Product Change Notification

1. ECR #: 205199
Notification #: 588

3. Series:
• STD ASP - null

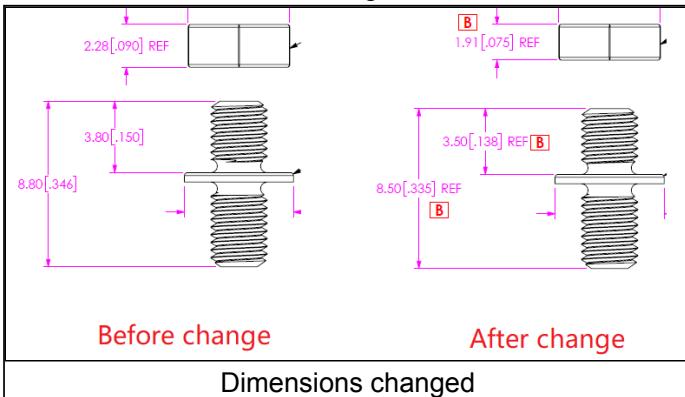
FRONT VIEW: CHG 2.28 REF TO 1.91 REF, CHG 3.80 TO 3.50 REF, CHG 8.80 TO 8.50 REF.

To enable the customers to expand/share JSOM P/Ns in multiple applications including all VITA applications, where it was impossible before and streamline & simplify Samtec's Standard product offering, we improved the length of the stud above lifting-shoulder on the JSOM adjuster to 3.50mm. Customers will still be able to use the old revision materials in many demonstration or non-VITA applications. Advantage over the old revision materials, new revision materials will expand the component area limits to 3.50 mm.

- Form - New revision materials will expand/improve the component area limits to 3.50 mm.
